Addendum 3

Project: Hamilton-Wentworth District School Board
REFERENCE NO. 2025-107-P02082
Hess Street Elementary School Ground Floor Ceiling Replacement and
Lobby / Classroom Renovation Project

Addendum No. 2

Project: HWDSB-P2024-2082 – Hess Street ES Renovation

SK01.0 AD#02

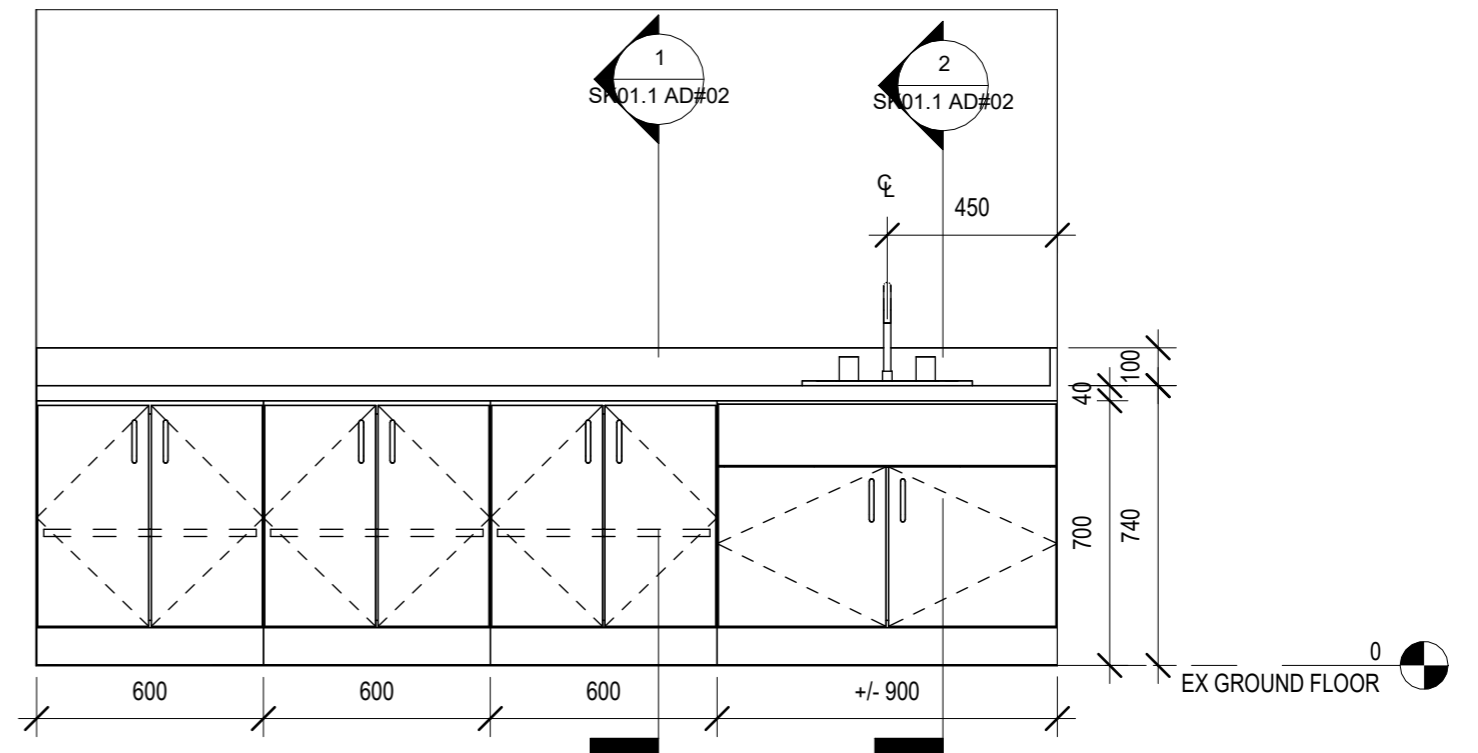
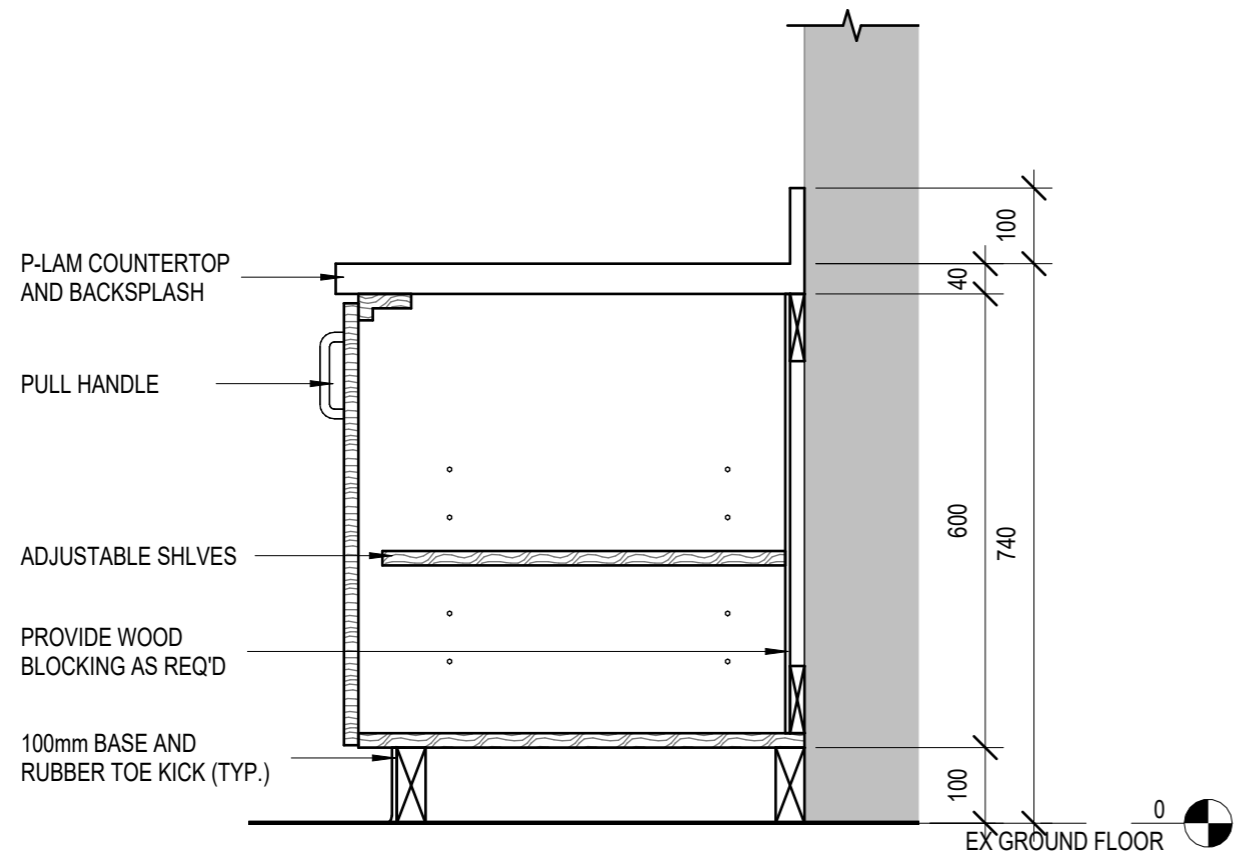
Q2. There was a mention of adding a sink and a countertop in classroom 112-A in the addendum. But it wasn't included in the addendum#1. Can you please confirm if we need to include in pricing? If yes, please provide specifications.

R2. Refer to the attached sketches SK-01 AD#2 and E&M Addendum#2 and Specification 06 40 00 Architectural Woodwork (7 pages)

Drawing E1-00

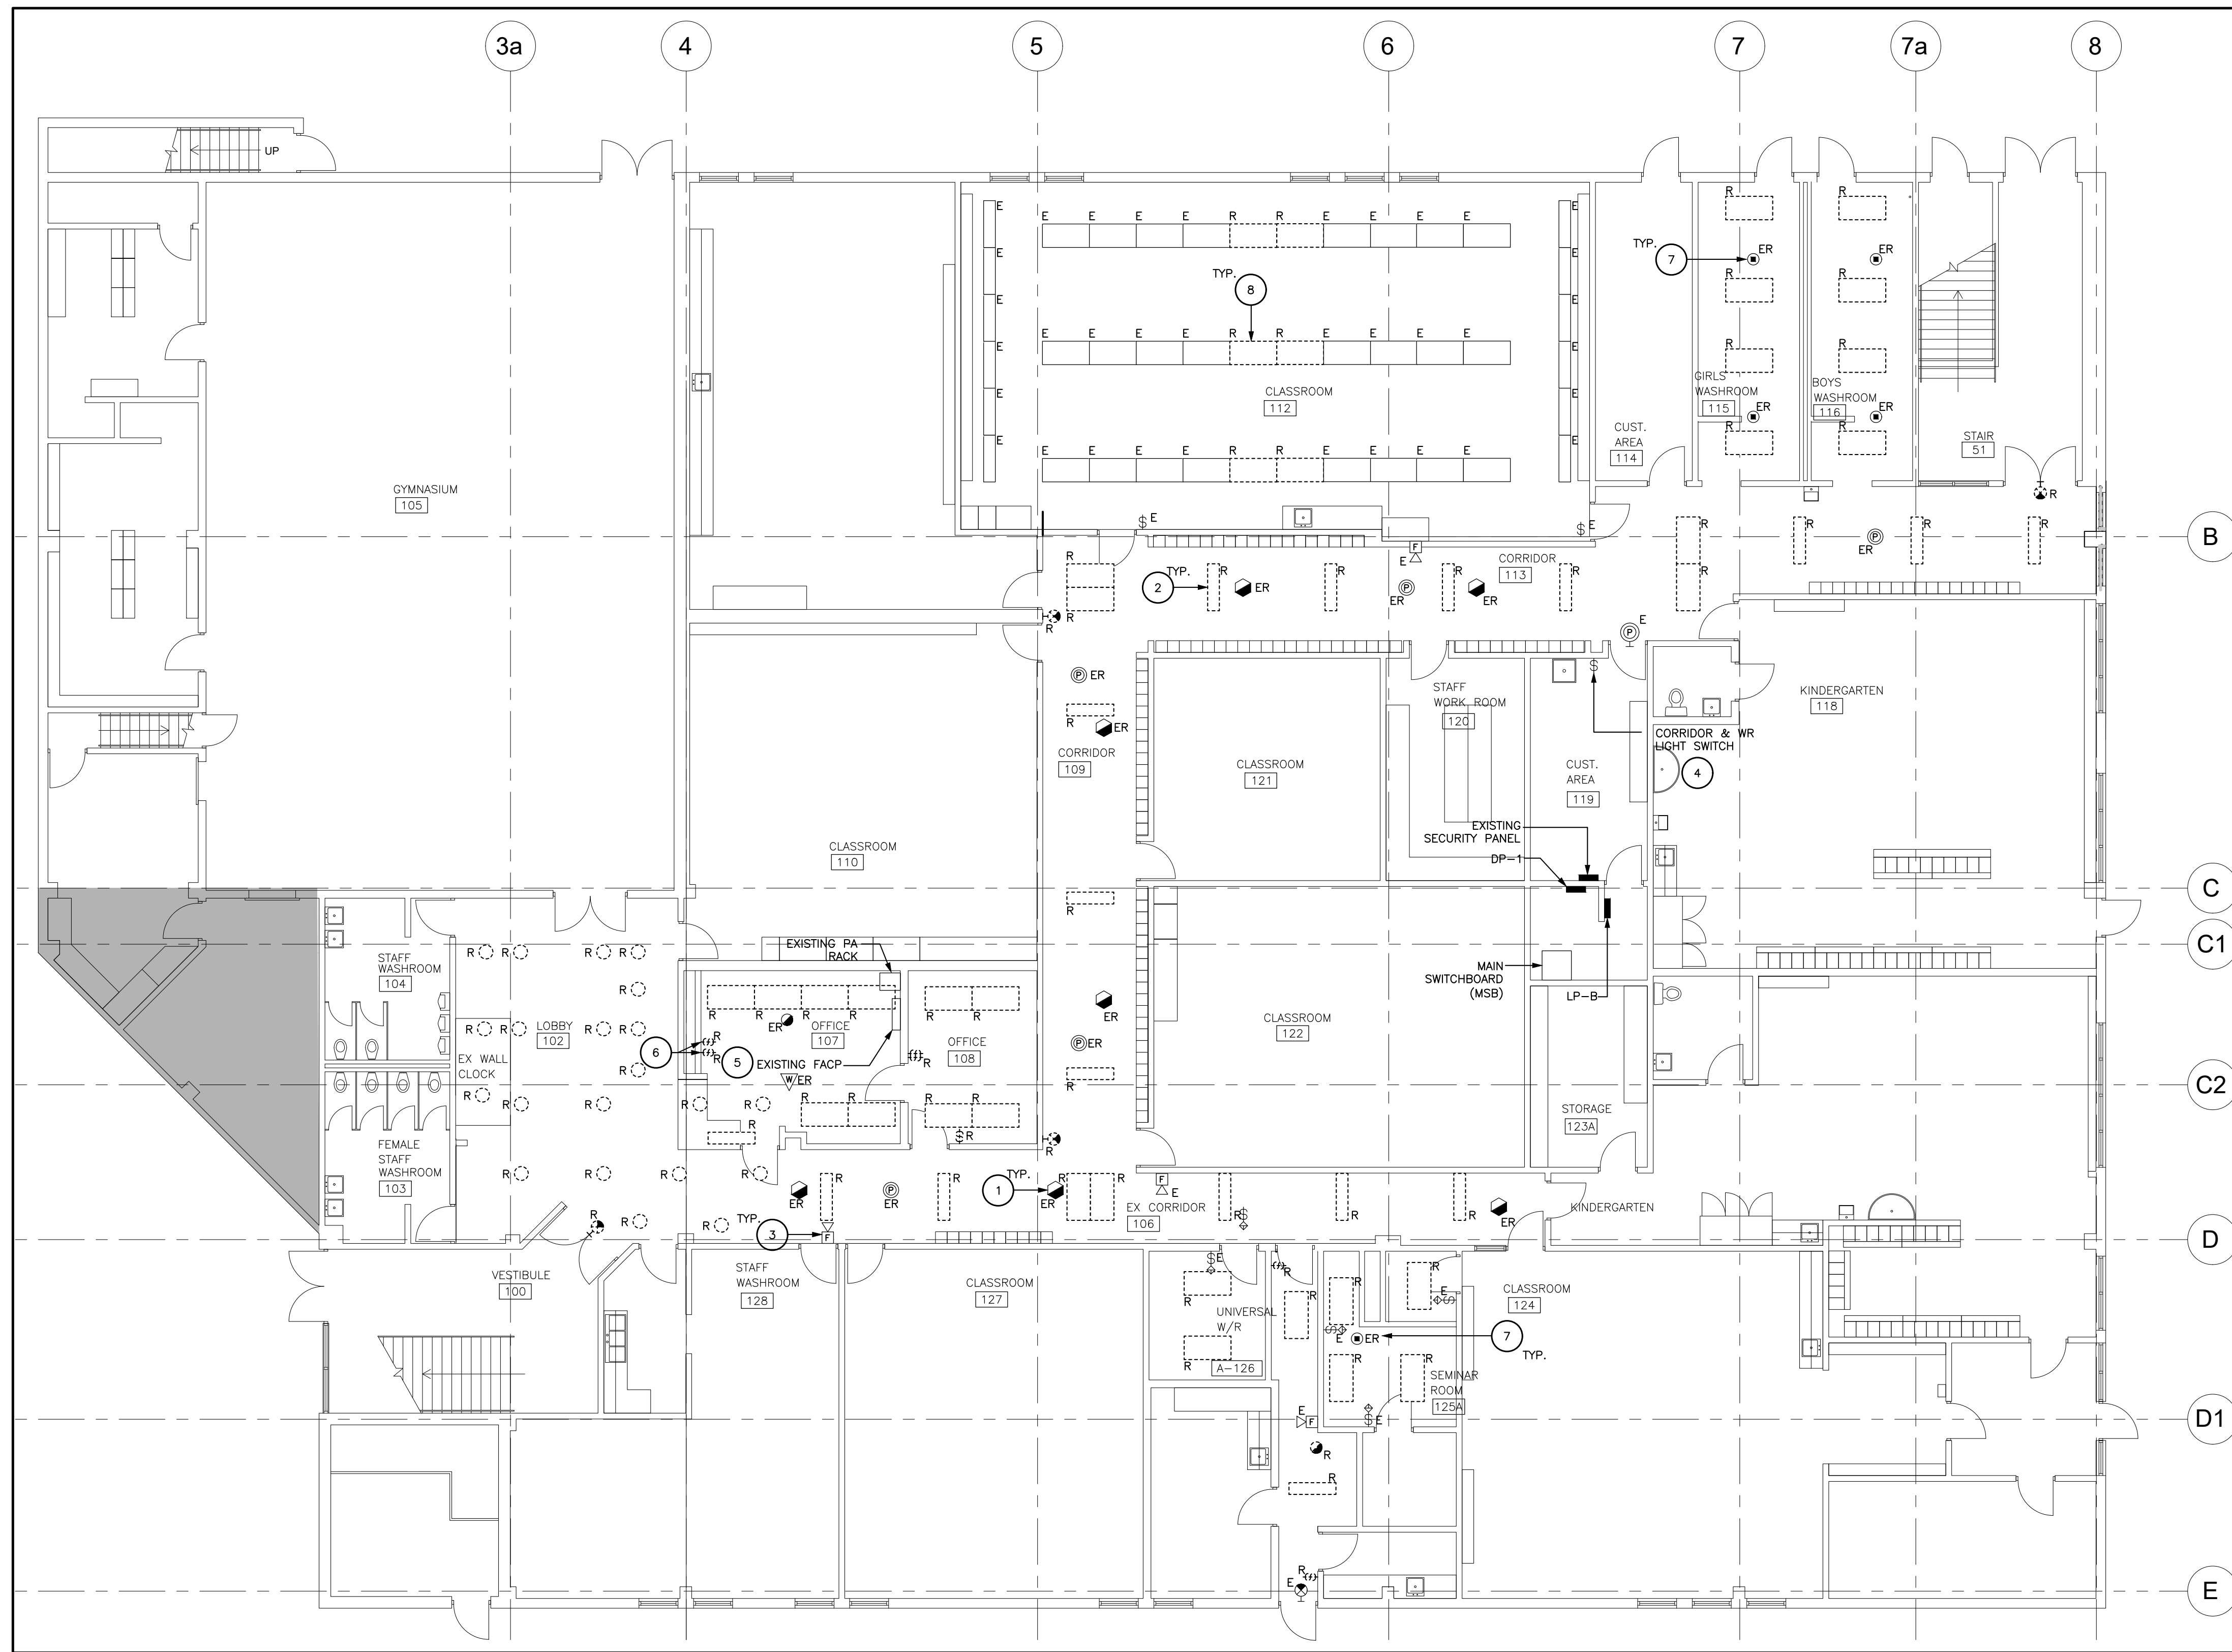
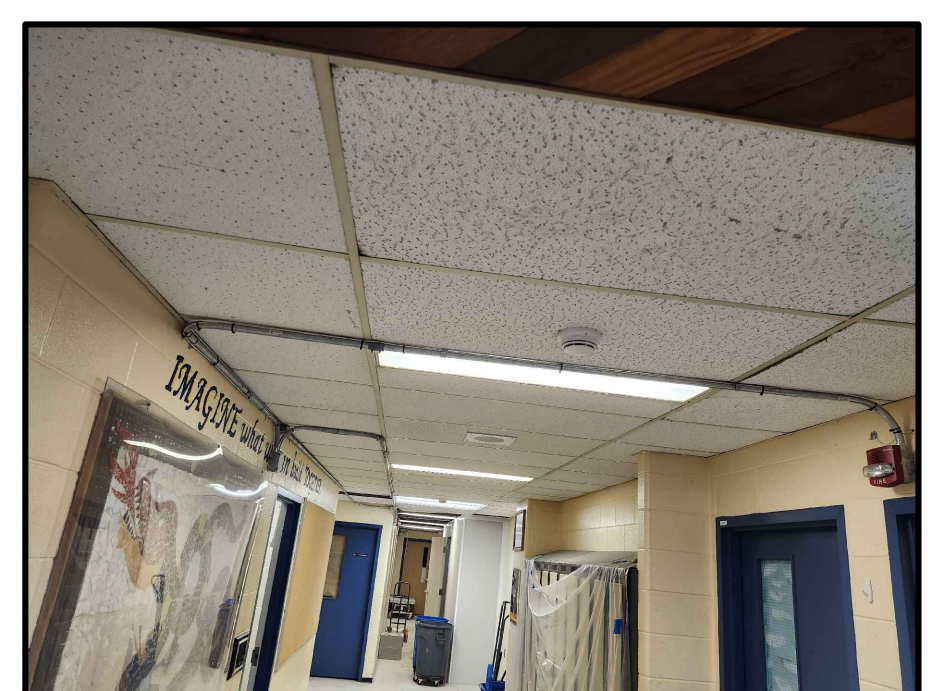
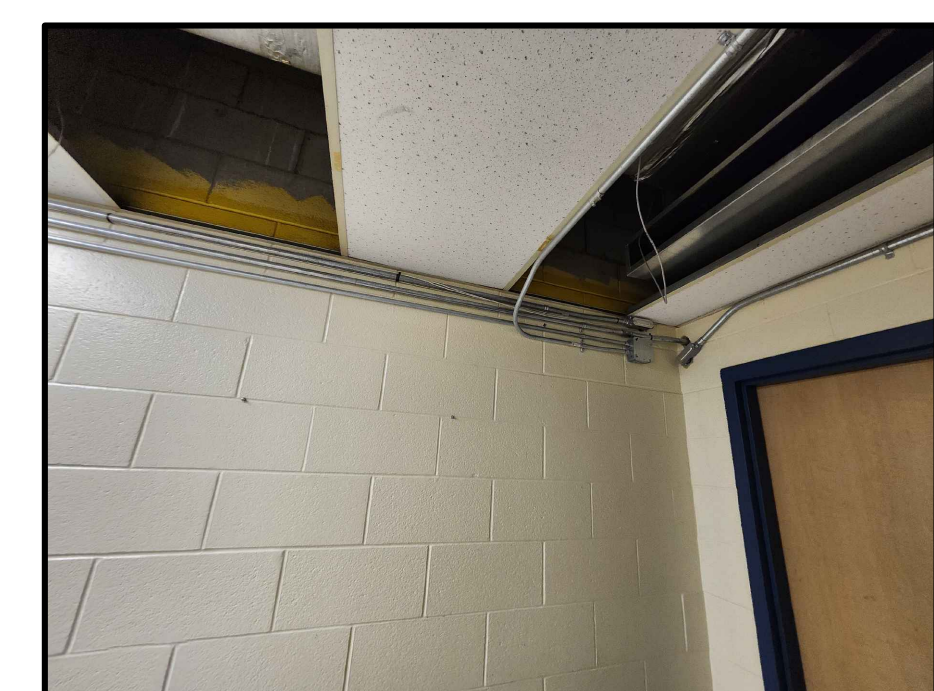
1. **REVISE** drawing note #2 as shown.

Drawing E2-00

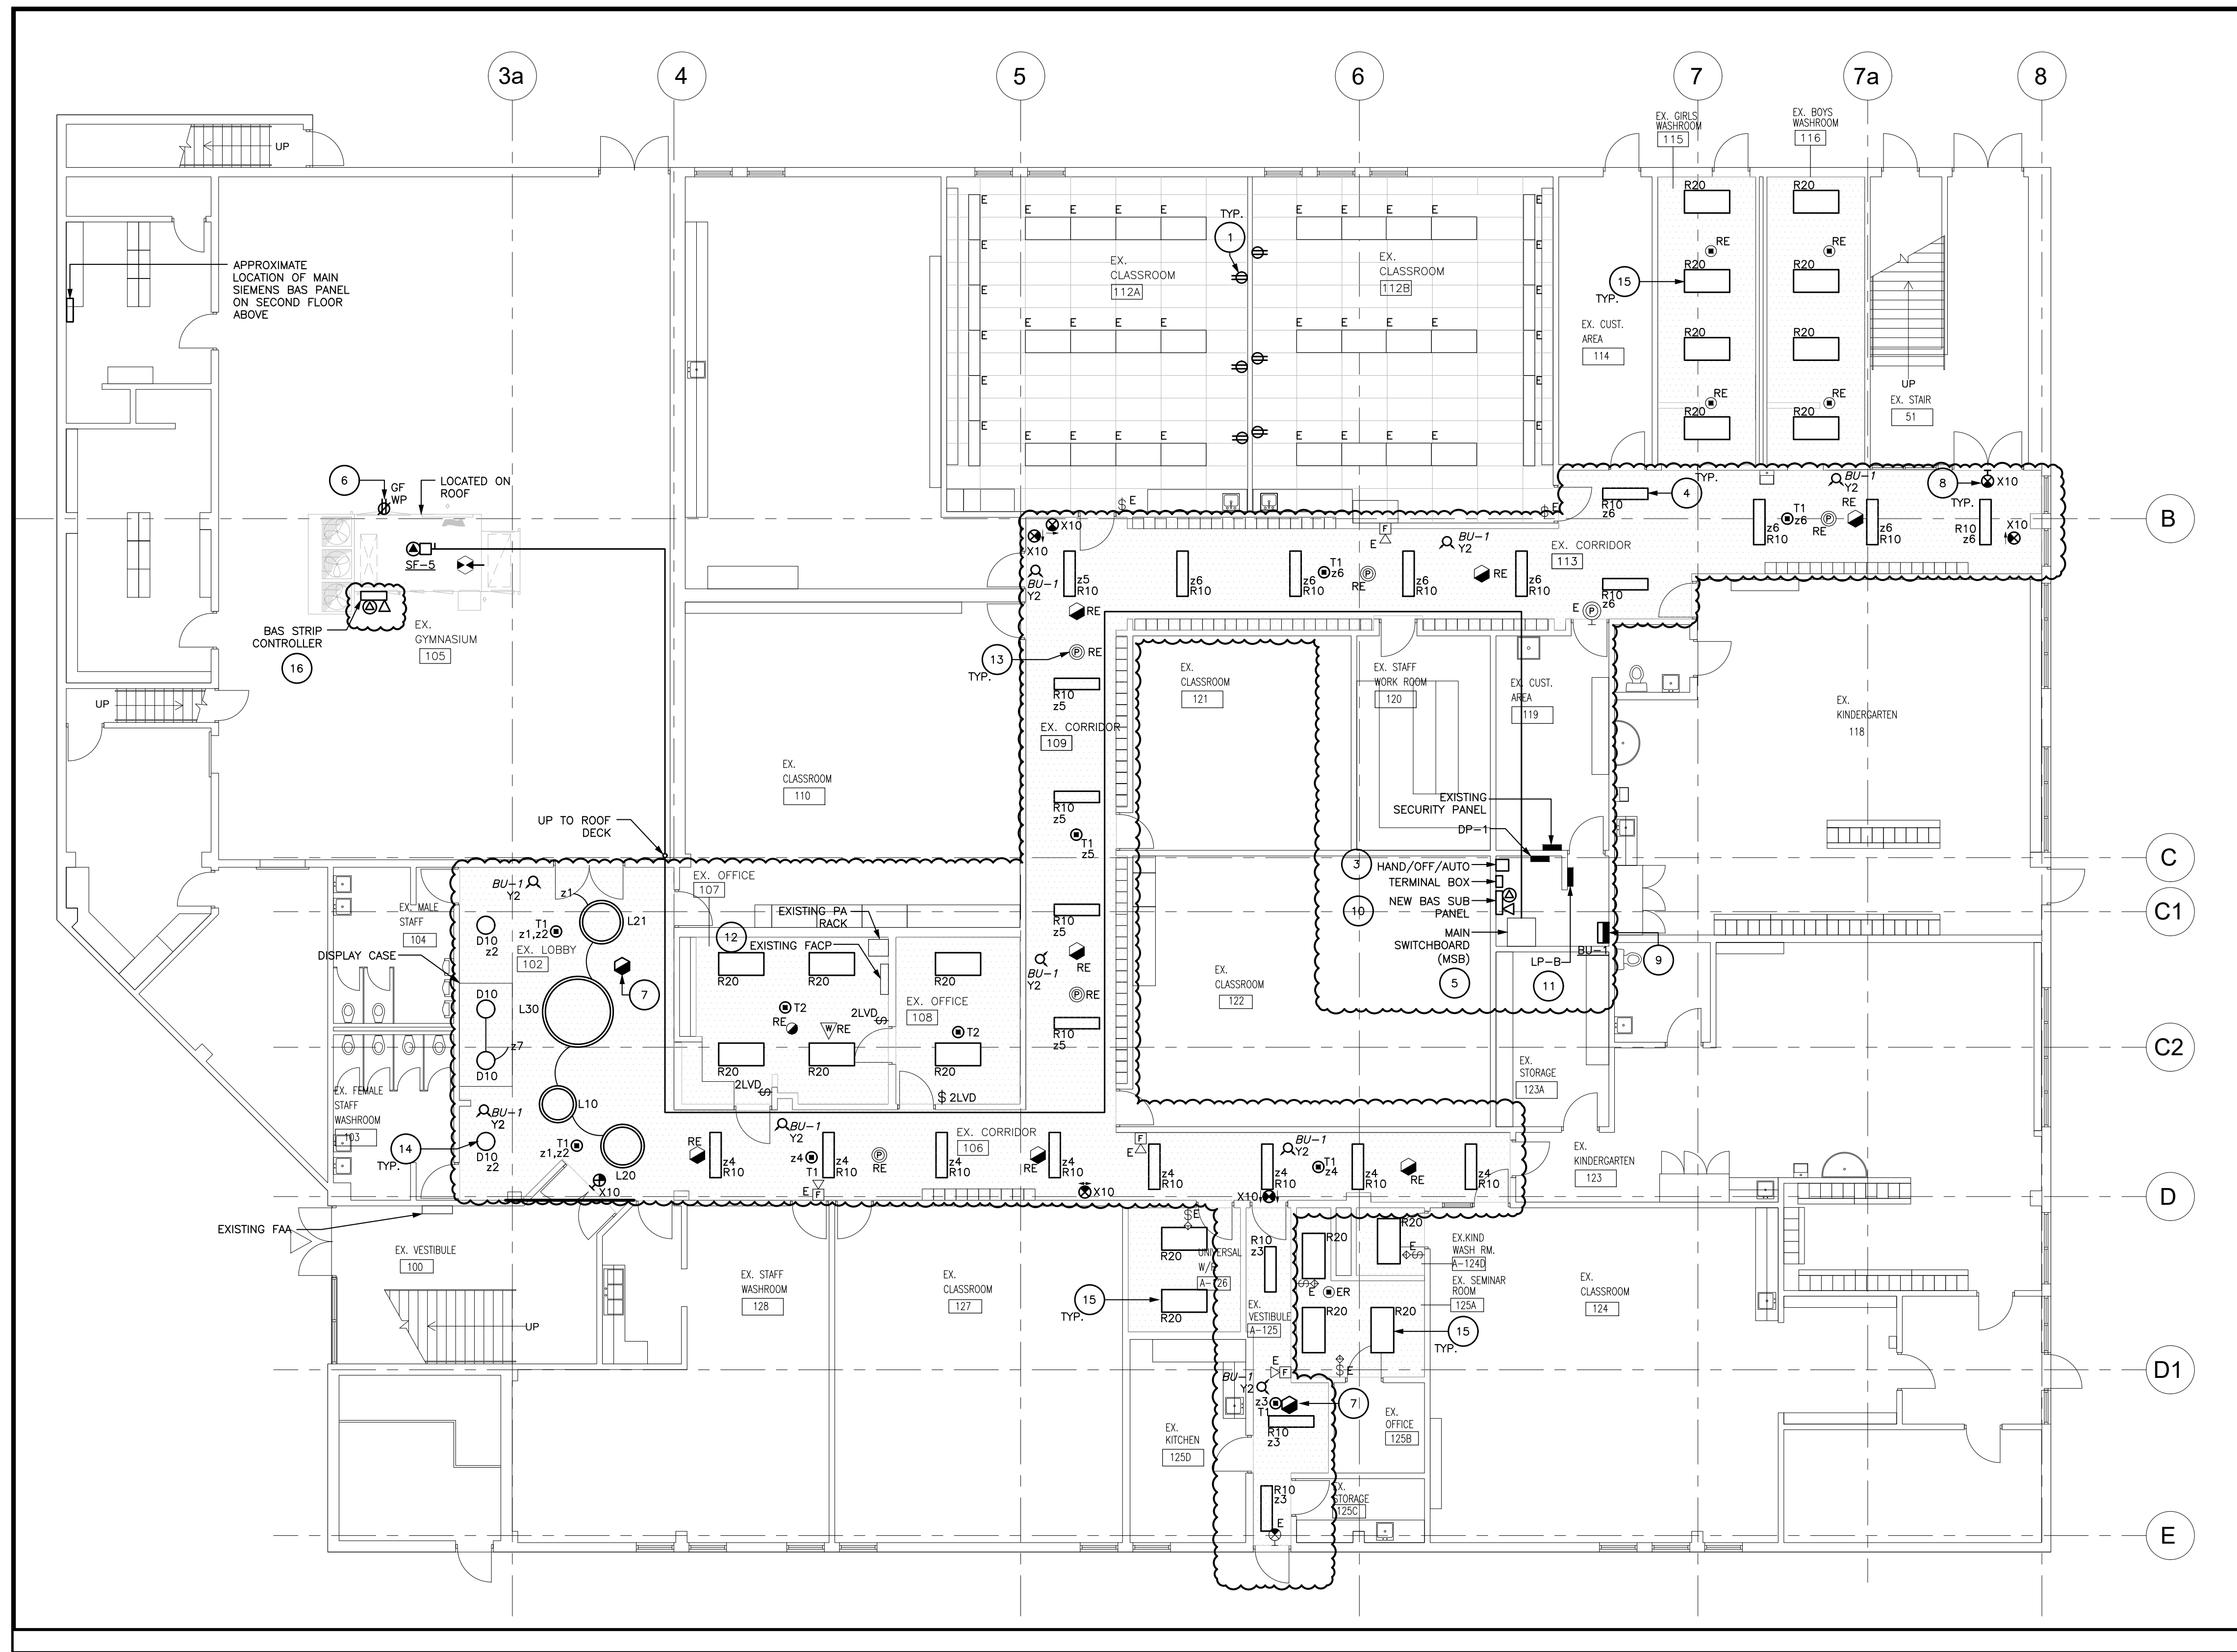
2. **REVISE** lighting control in corridors and lighting control types as shown.
3. **REVISE** drawing notes 6, 9, 10, 11 as shown
4. **REVISE** occupancy sensor type T1 as shown.
5. **REVISE** voltage of fixture types L10, L20, L21, L30 as shown.
6. **ADD** data connection to BAS strip controller in SF-5.
7. **ADD** new BAS sub panel.
8. **ADD** battery unit & remote heads as shown.
